Opal St Clair

Response to letter 19th November 2021

17th June 2022

ITEM 3 – Concerned raised

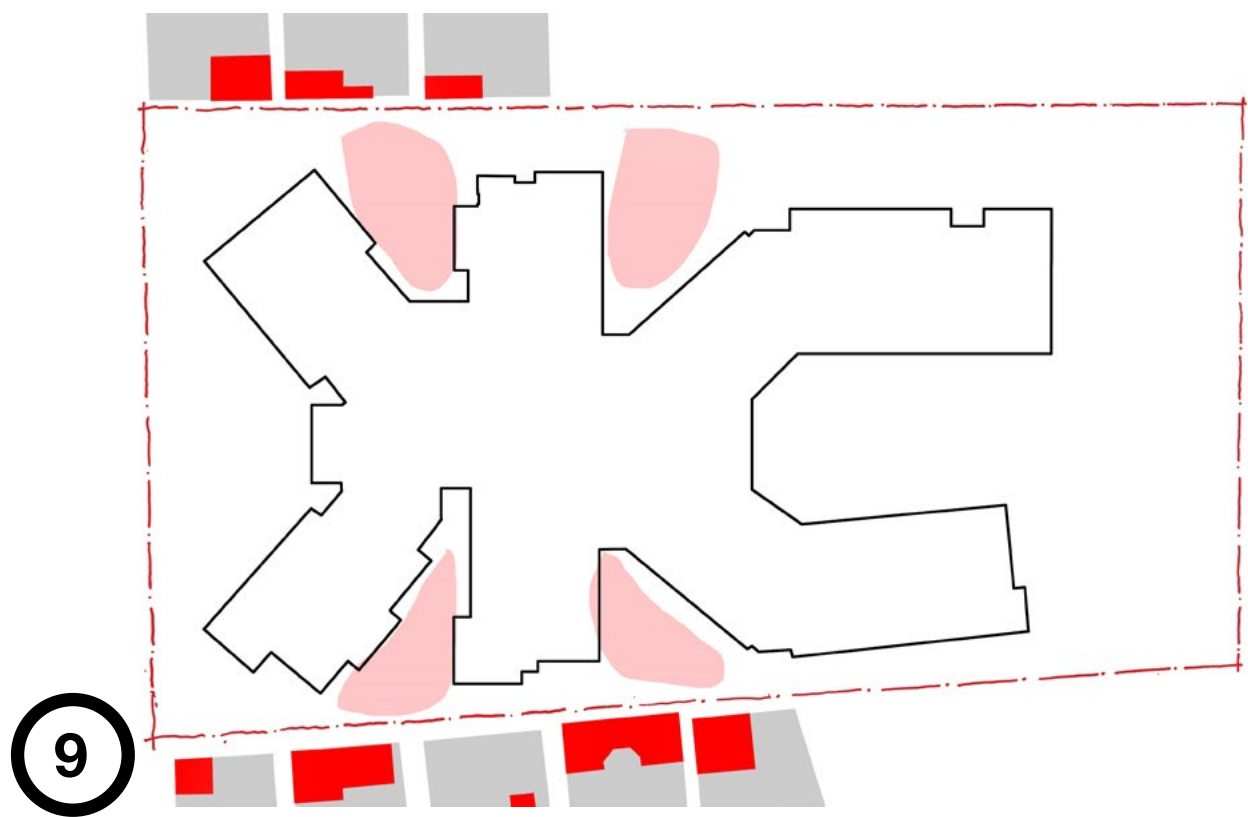
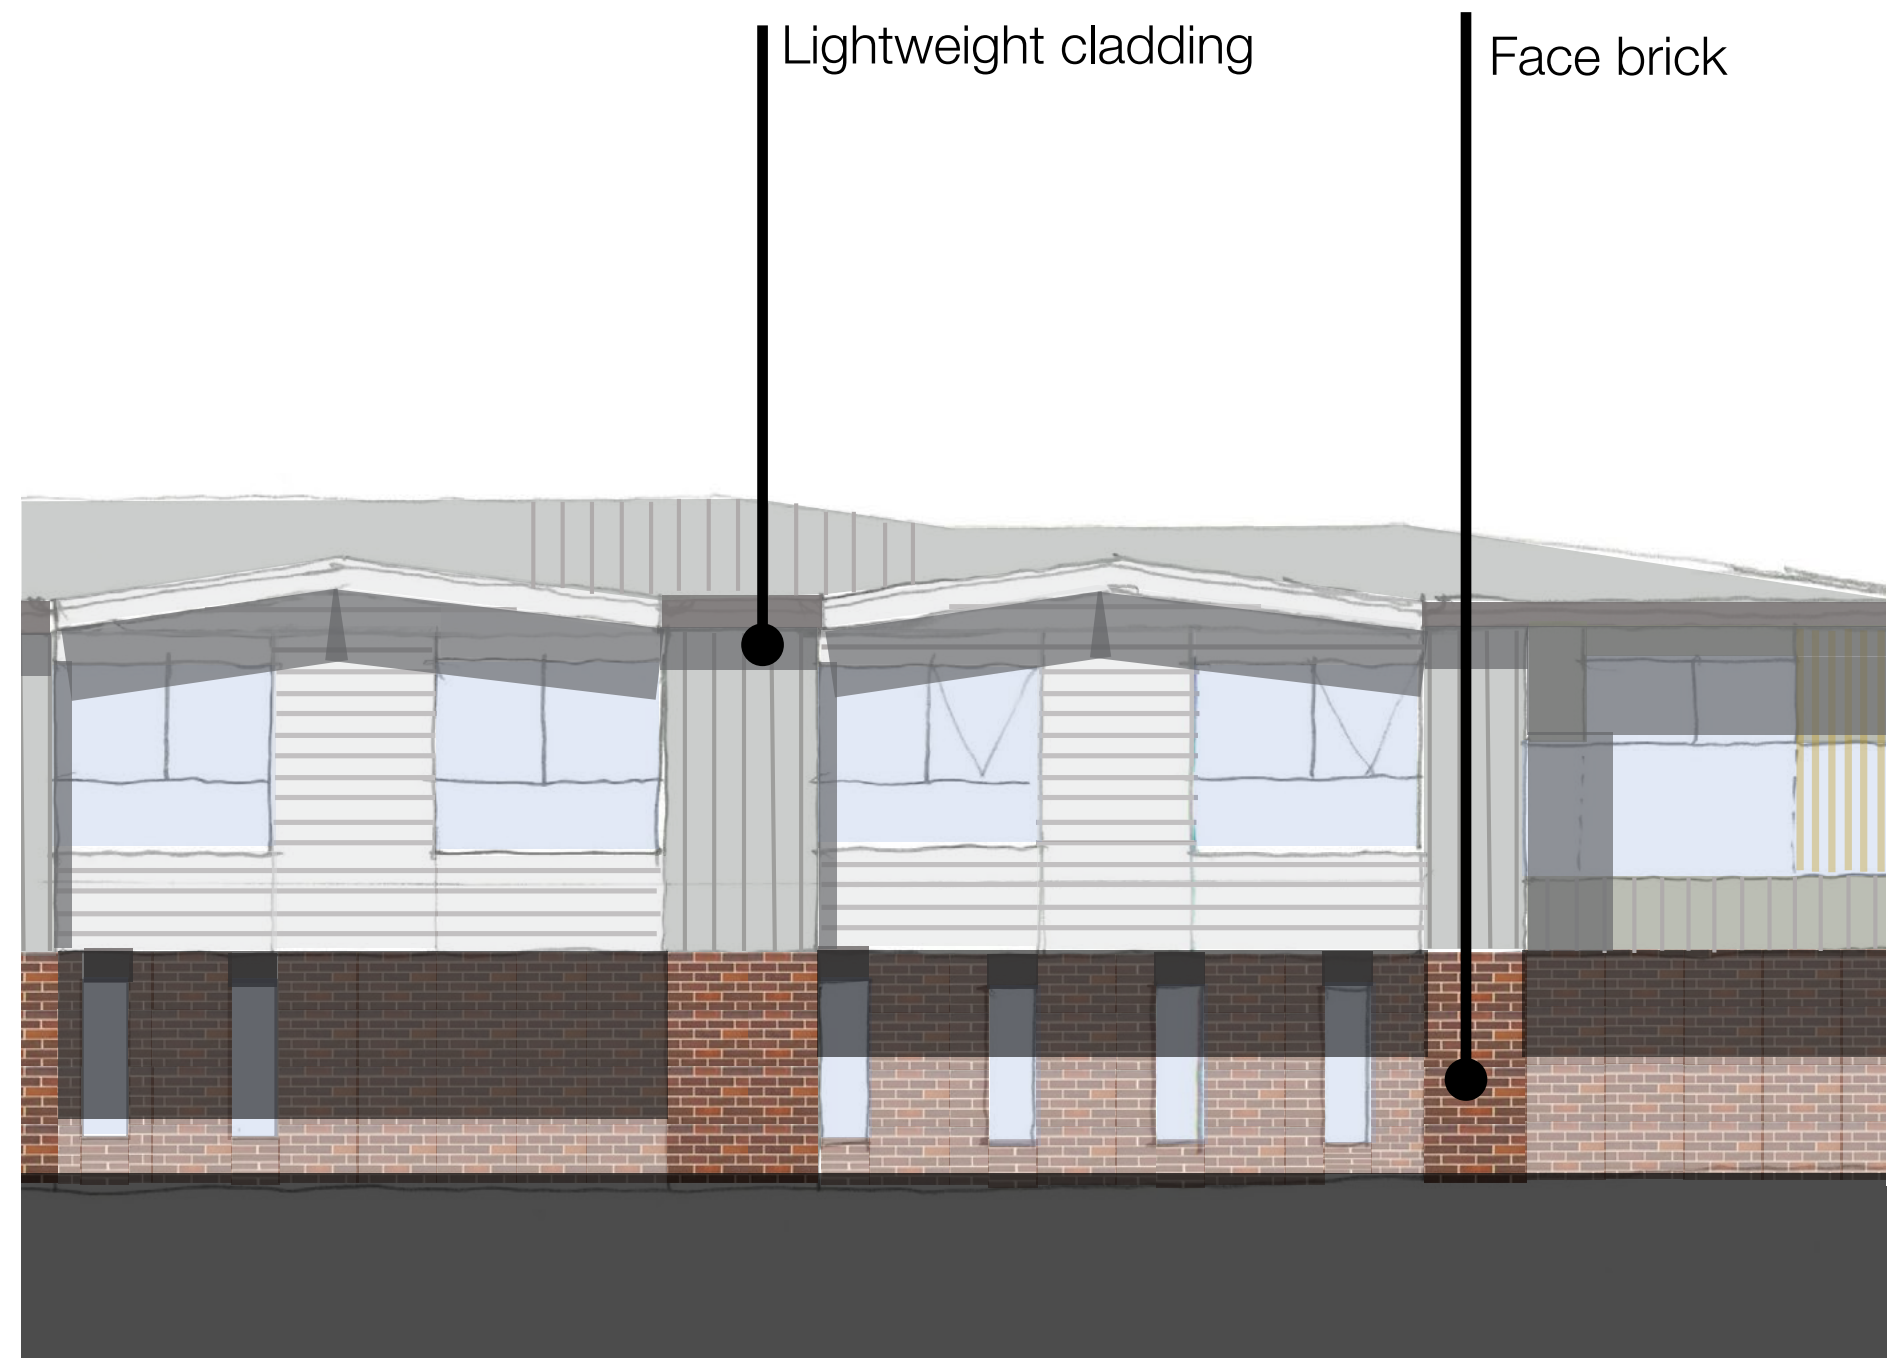
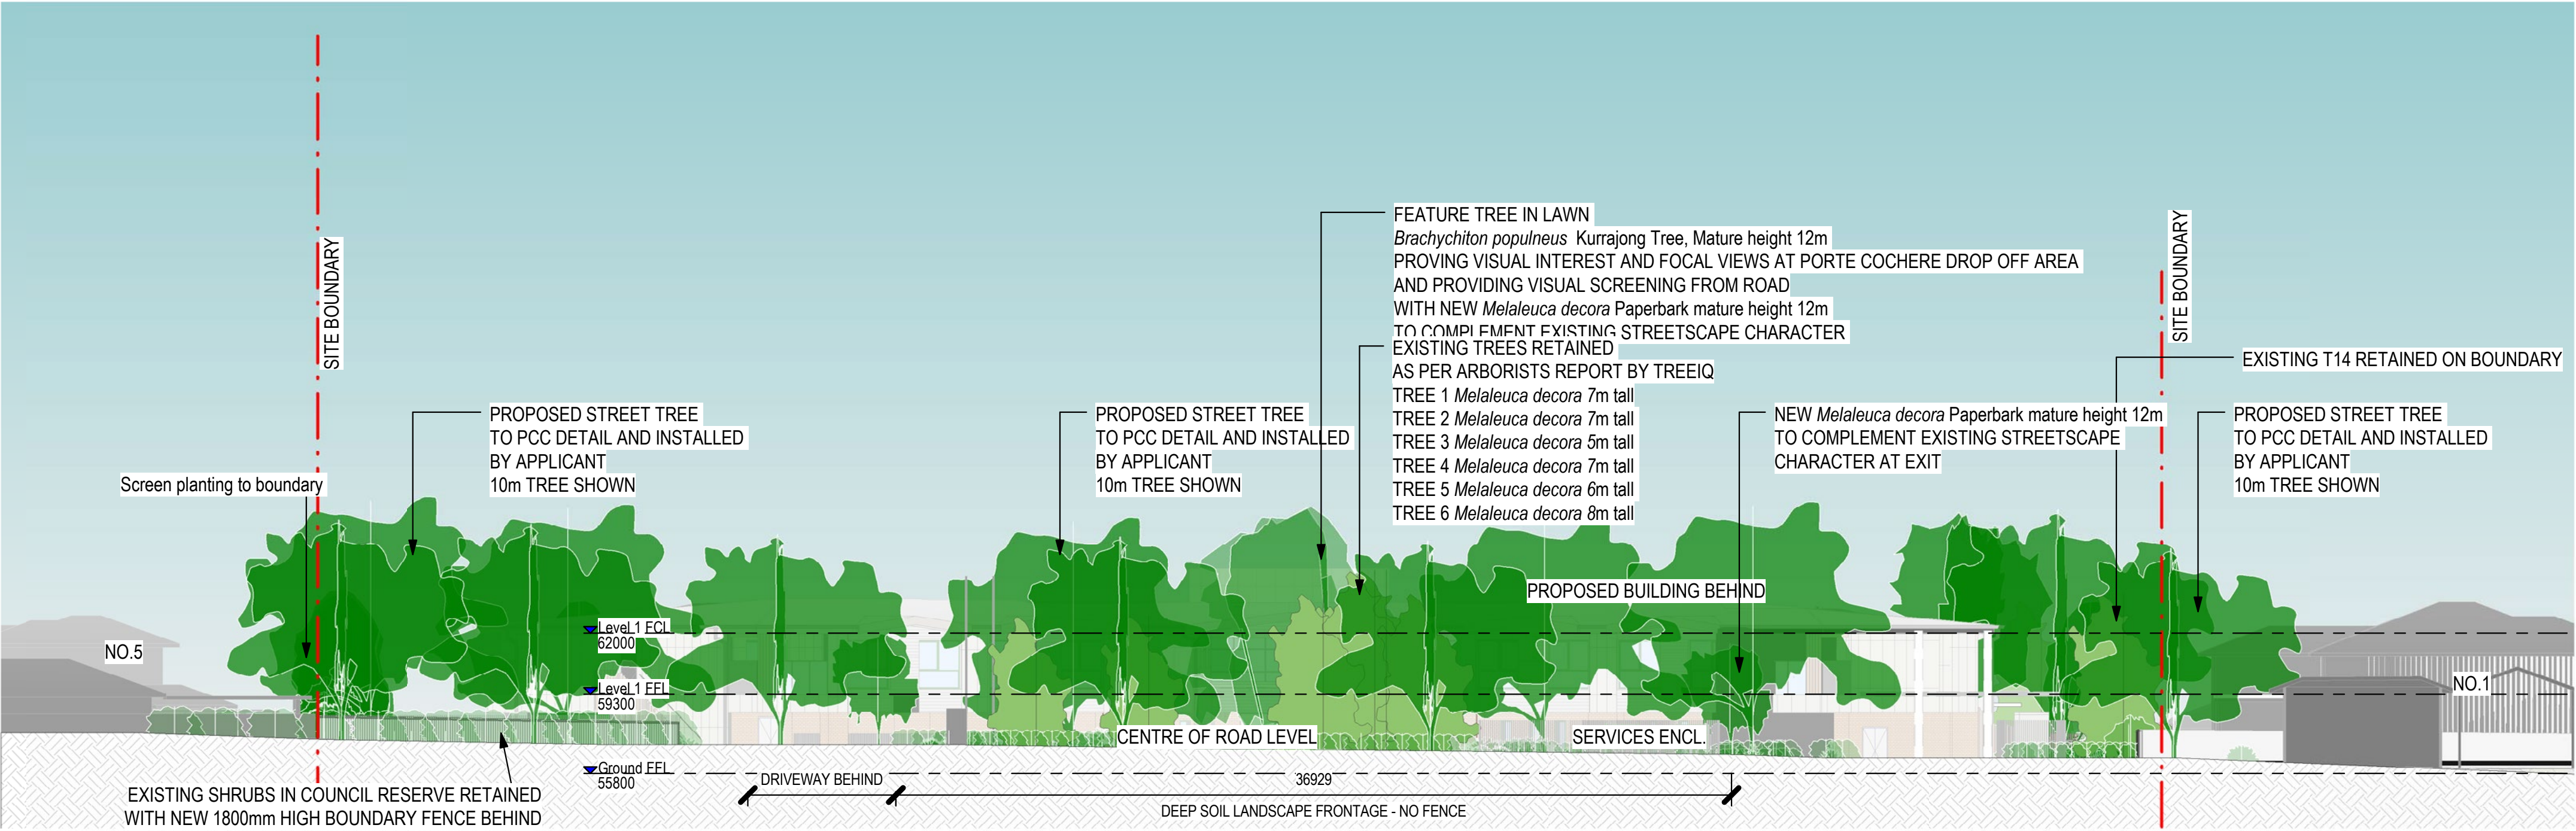
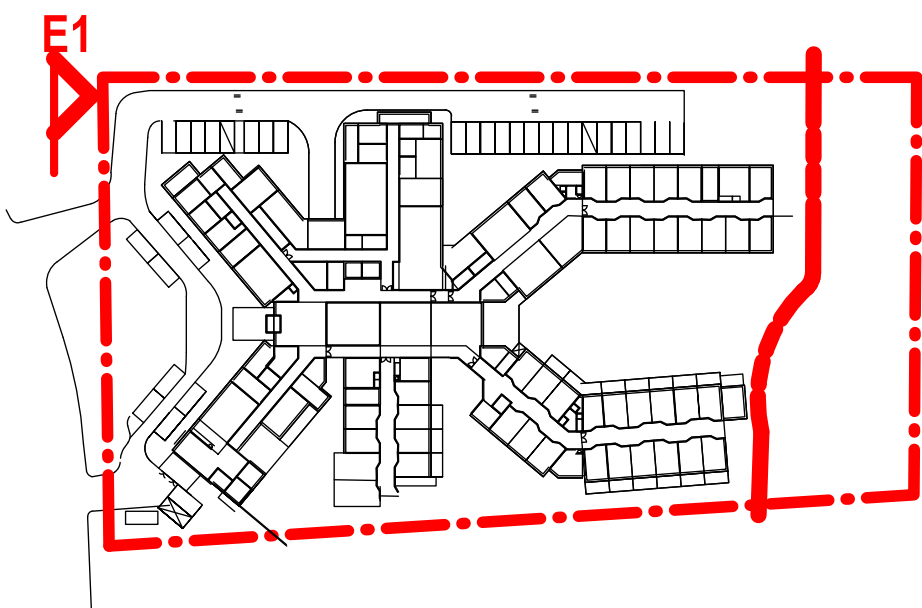
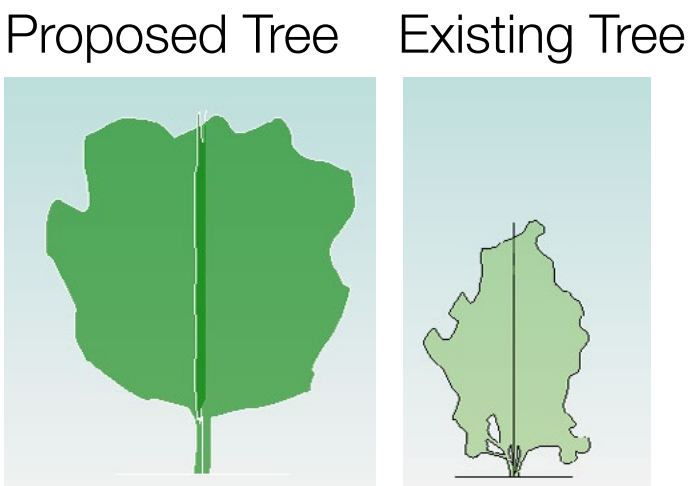
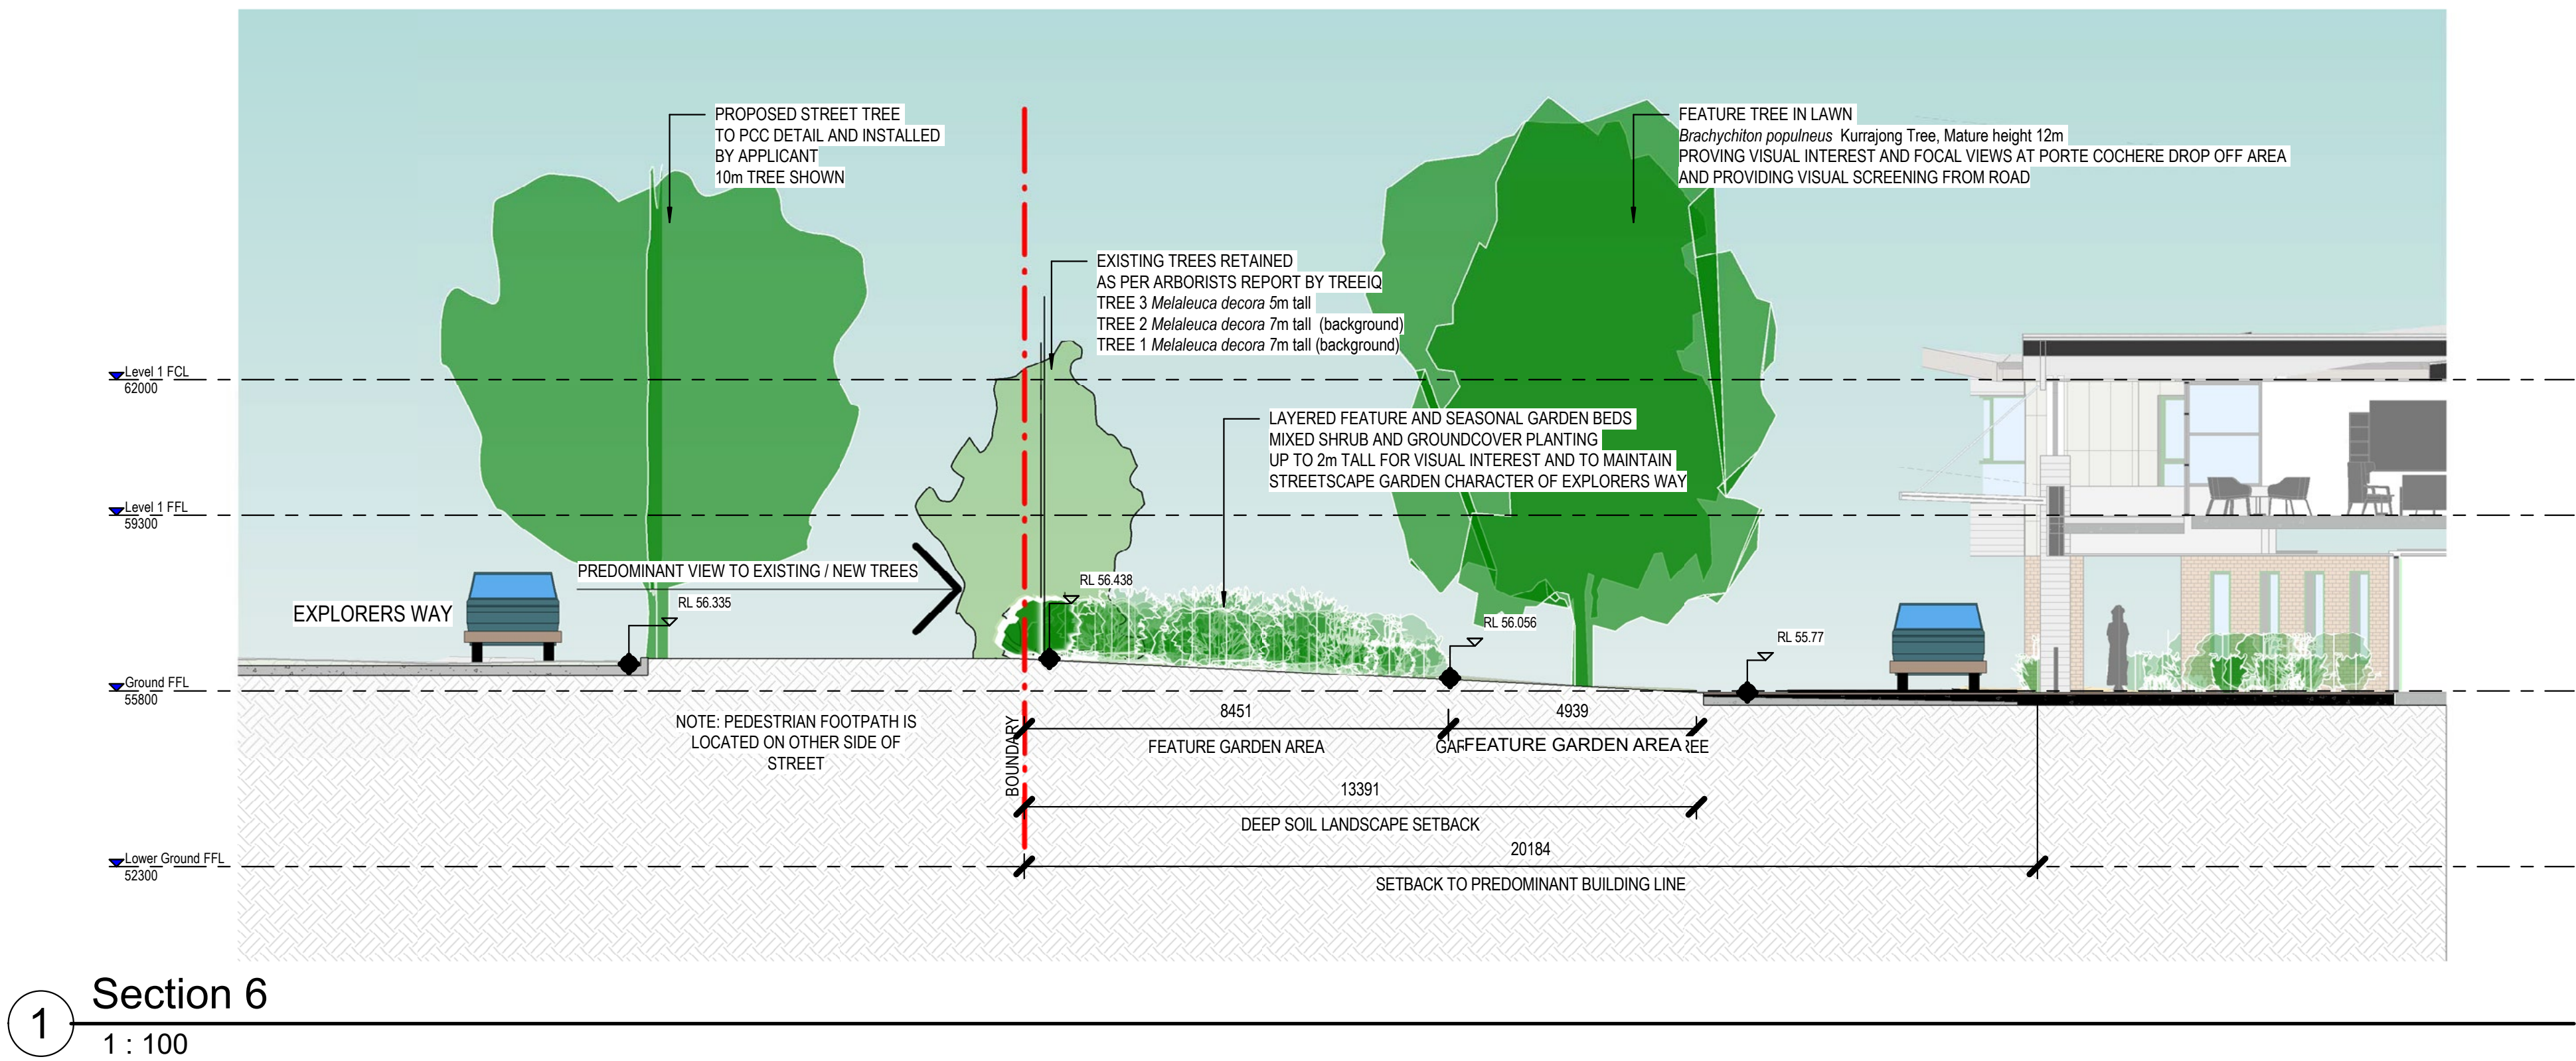
Concern is raised regarding the proposal from a streetscape and a residential / neighbourhood character perspective, including given the treatment of facades, and the placement and alignment of utility infrastructure within the front setback area. It is noted that Council's Urban Design Review Panel have reviewed the proposal and have raised issue in this regard, in relation to the dominance of the street setback by hardscape, surface parking and services, and the colour scheme and reliance on painted render.

The services / utilities along the front boundary were located in the position shown on the site plan for the following reasons:

The services are located at the front of the property as the authority services in the street verge and footpaths are directly in front the locations as the follow the road and turn 90 degrees under the road surface and follow the road. If moved to the other end of the site, all authority services mains, water and gas, would need to be extended along the front of the site.

The booster is required to be located at the site boundary and within 8m of a hardstand area as required by AS2419.1-2005,cl 73 (d) as below
